Docket Number:	01-AFC-07C
Project Title:	01-AFC-7C Russell City Energy Company
TN #:	221118
Document Title:	Russell City Energy Company, LLC Responses to CEC's Data Requests, Set 1A, A1 through A16
Description:	N/A
Filer:	Deric Wittenborn
Organization:	Ellison Schneider Harris & Donlan LLP
Submitter Role:	Applicant
Submission Date:	9/11/2017 4:30:35 PM
Docketed Date:	9/11/2017

Responses to California Energy Commission Staff's
Data Requests, Set 1, A1 through A16

Russell City Energy Company, LLC

California Energy Commission Staff's Data Requests Set 1, A1 through A16

ATTACHMENT 3

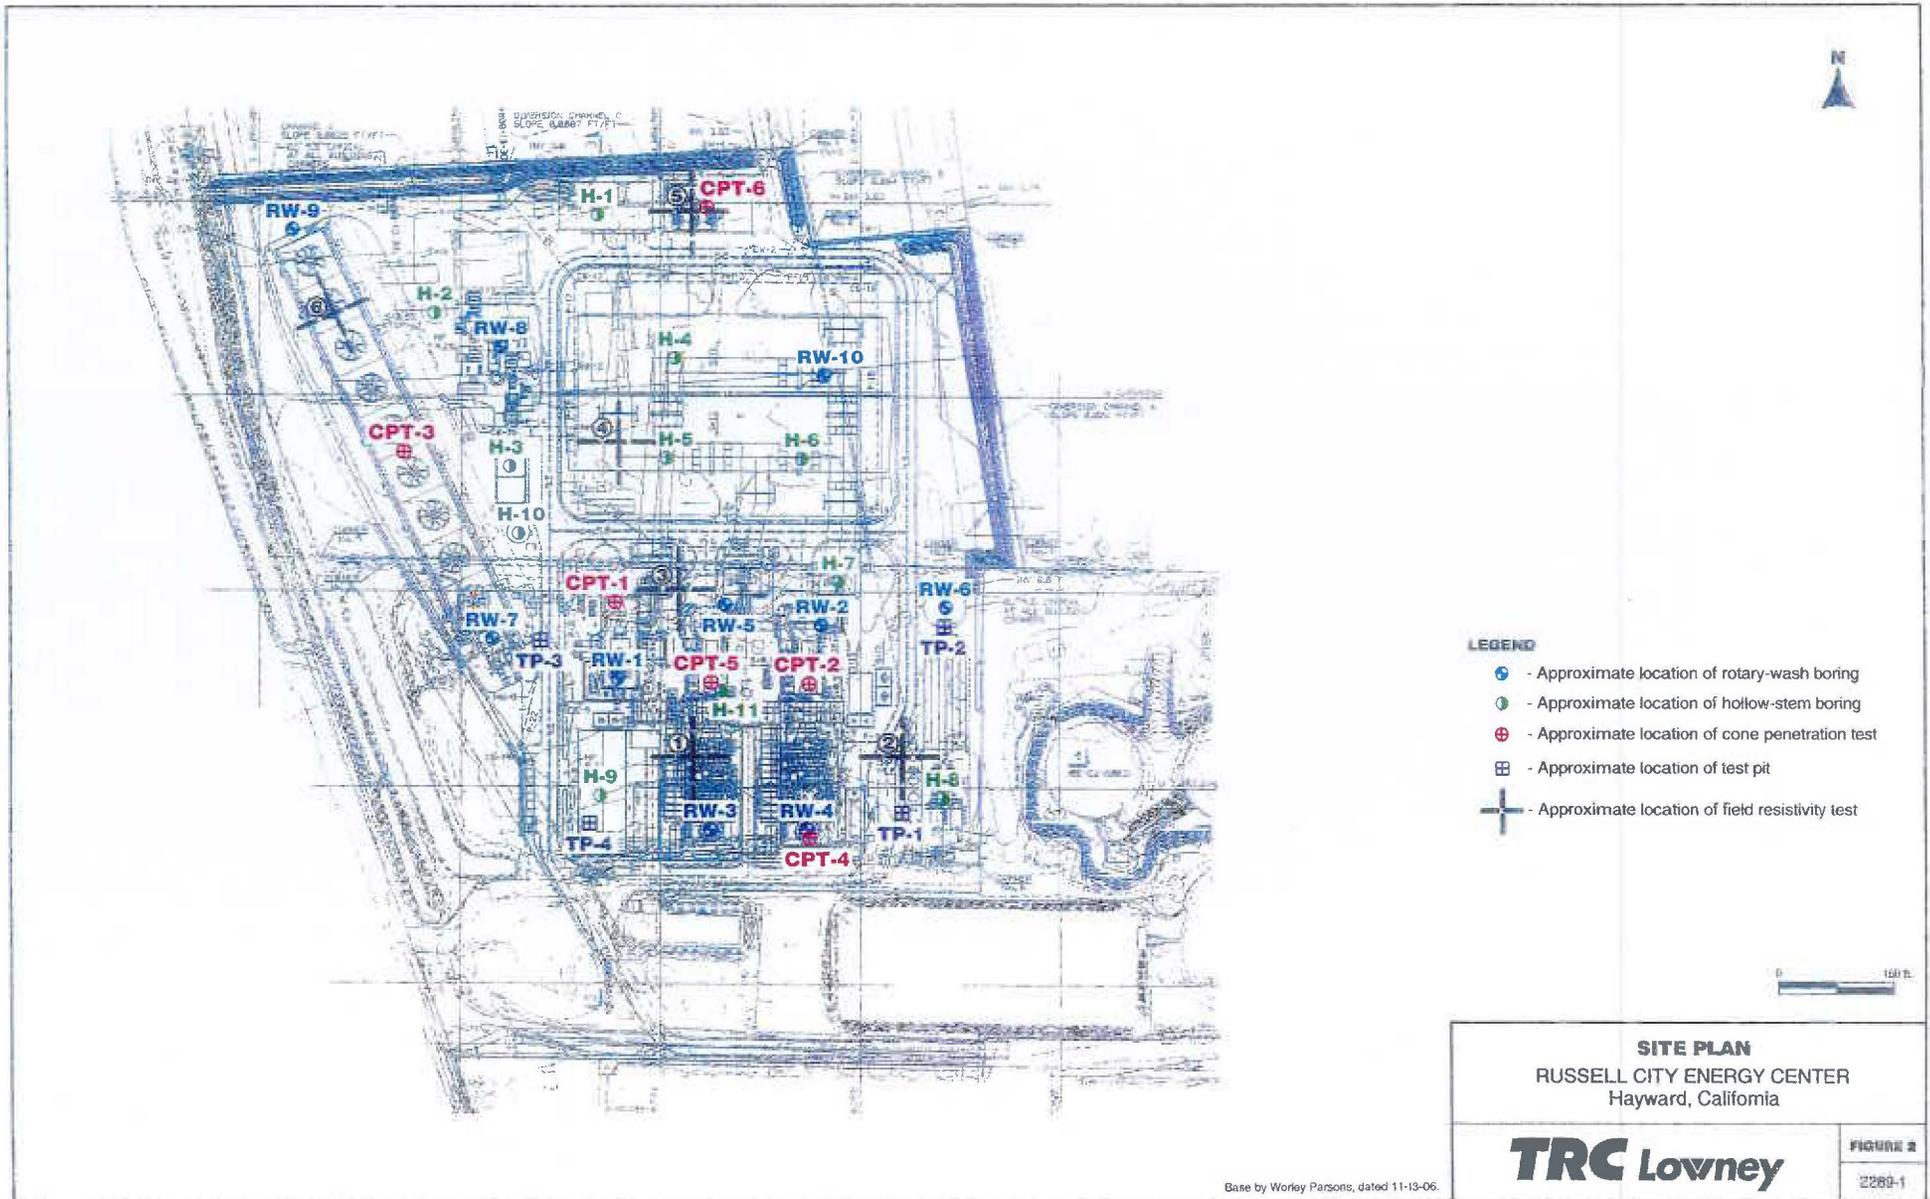
- A5. *Please provide a site plan or map that clearly demarks the extent of the "preexisting fill" area. If the source of the fill is known, please include that information.*

RESPONSE: Please see Attachment 3. Attachment 3 includes excerpts from the Geotechnical Report prepared by TRC Lowney on February 12, 2007 for RCEC. The tank construction will take place in the area of soil boring H-3 as indicated by the Site Plan (Figure 2) in Attachment 3. Table 7 of the report states that fill in that area is 4.5 feet and the depth to native soil is 4 feet. Although excavation will be required for the construction of the tank foundation, the excavation will not exceed 4 feet in depth. The source of the fill is unknown.
